**Letter BA: Carey Glenn (January 8, 2021)**

Re: Opposition to SE-PLR-2, Templeton – S. River Route Alternative

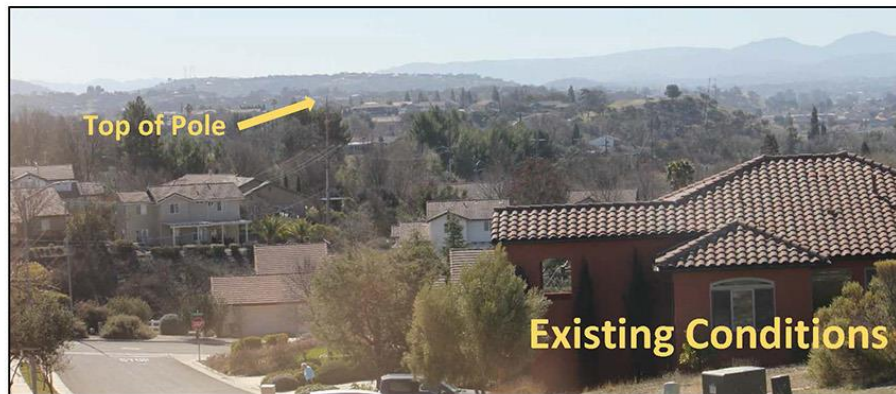
BP-10 The existing power pole on my lot is wood and has an existing height of about 55 feet. The width of the pole at the ground is 18 inches. PG&E has told me that the replacement pole is slated to be approximately 95 feet in height and given its size, presumably it will be one of the TSPs. If so, the base could be as wide as 5 feet. The height differential between the existing poles and the replacement poles will have a substantial and negative visual impact on homes abutting the line and viewsheds from those properties. Additionally, steel color poles are commonly associated with industrial settings, not residential neighborhoods.
